# Western Rail Coal Unloader

## ENVIRONMENTAL ASSESSMENT SUBMISSIONS REPORT

■ August 2007

Figure 2-4  
Viewsheds from CU, PB and WR

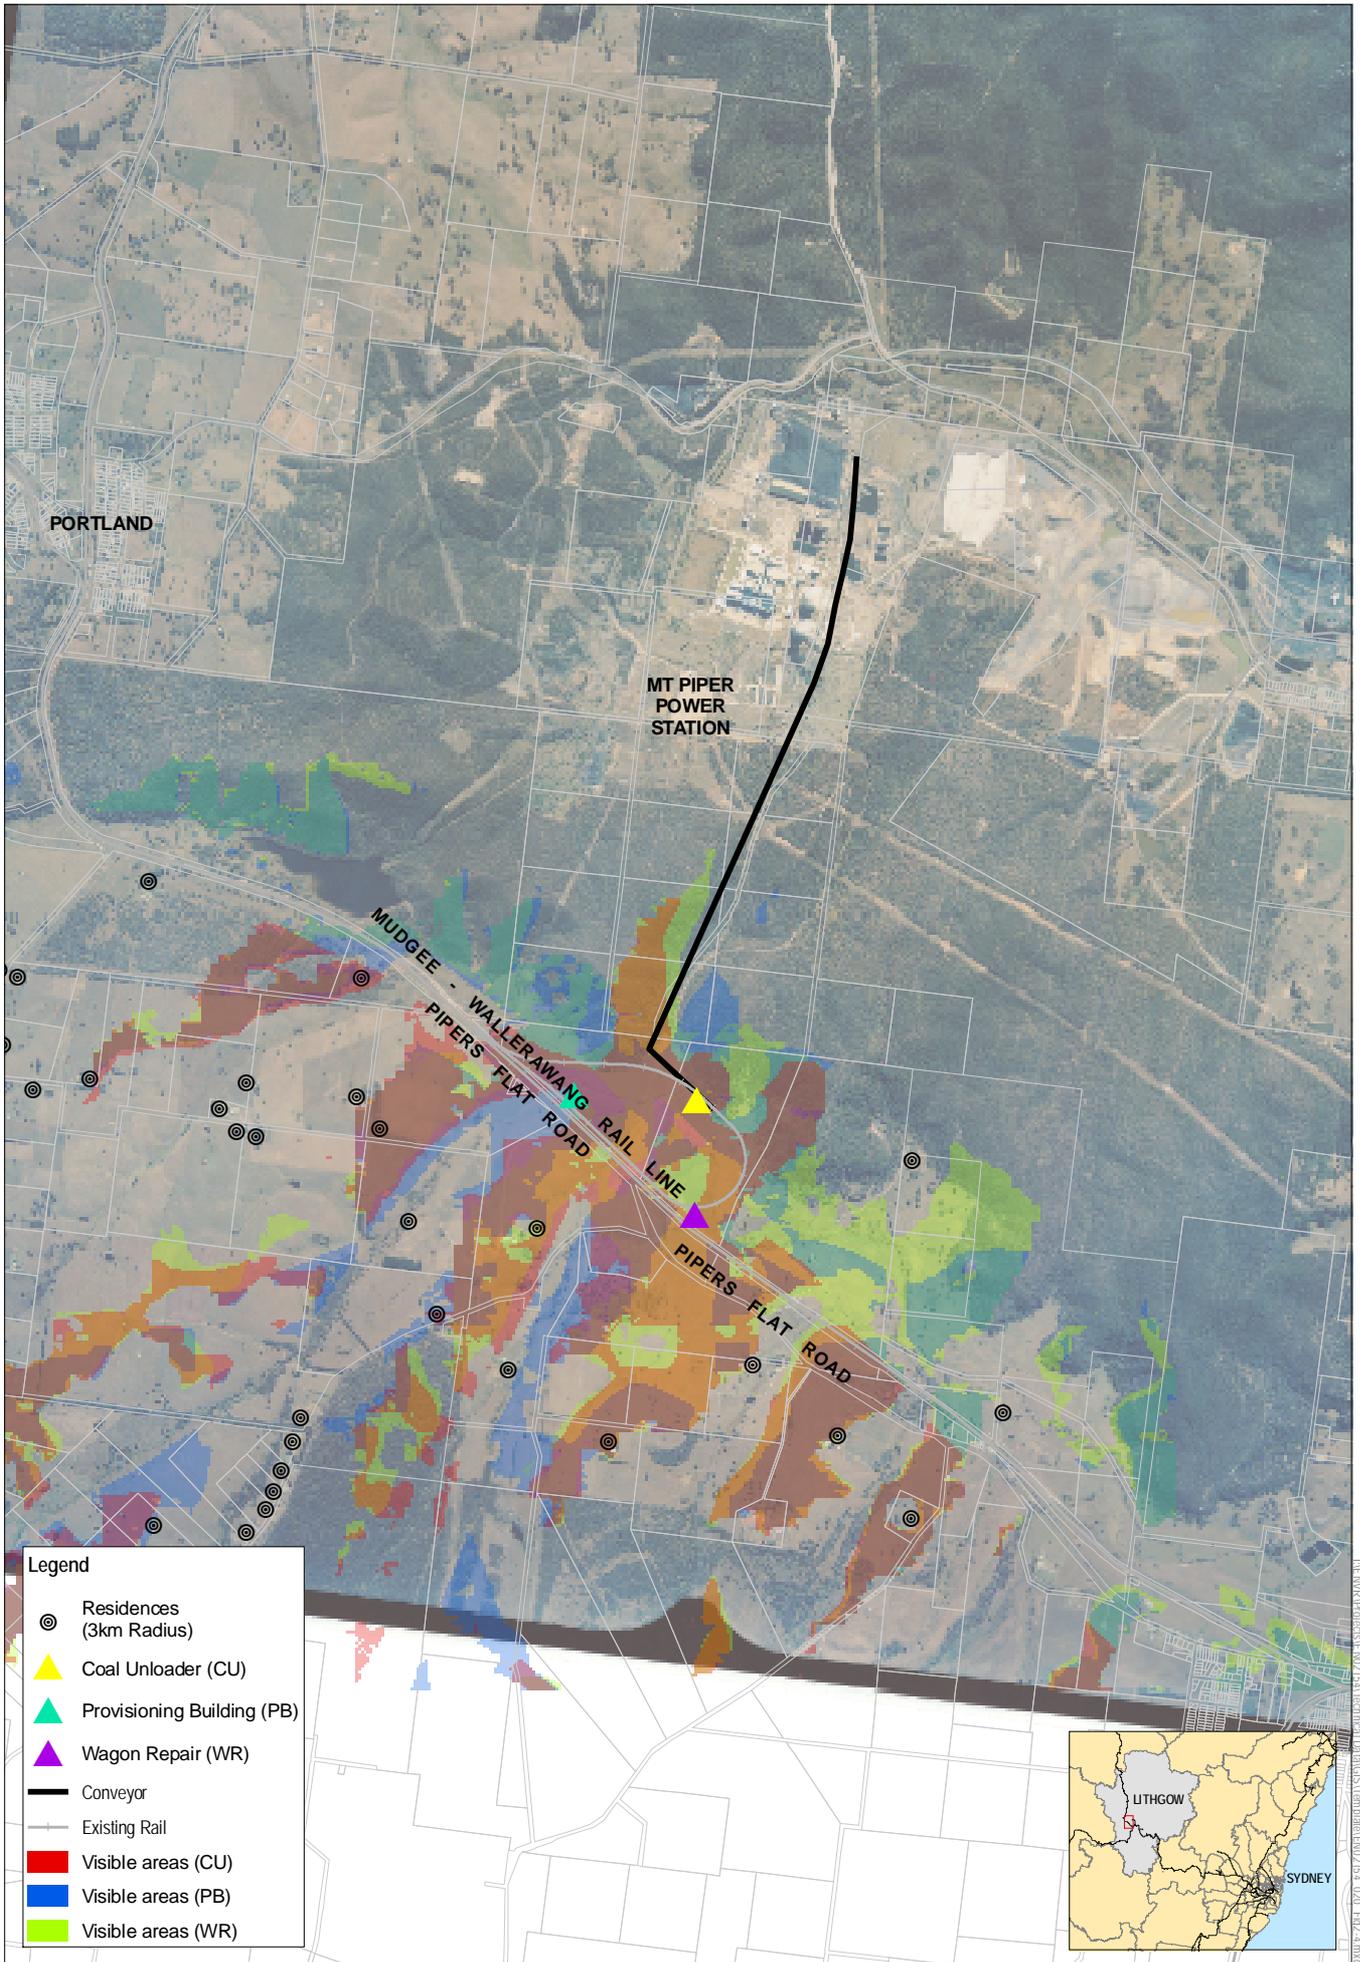
- Revision of Figure 5-10 such that it is expanded to a 3 kilometre radius from the view item (ie coal unloader structure) and it overlays residences in that area;
- A similar revision to the above but for the rail provisioning structure in isolation;
- A similar revision to the above but for the wagon maintenance area (including hardstand area with repair wagons) in isolation; and
- A figure consolidating the above figures (with residences overlaid).

Landscape planting is proposed for the rail embankments and for site buildings and screening vegetation along the southern site boundary would assist with screening views from Pipers Flat Road.

On the basis of implementing these mitigation measures, residual visual impacts would be regarded as low.
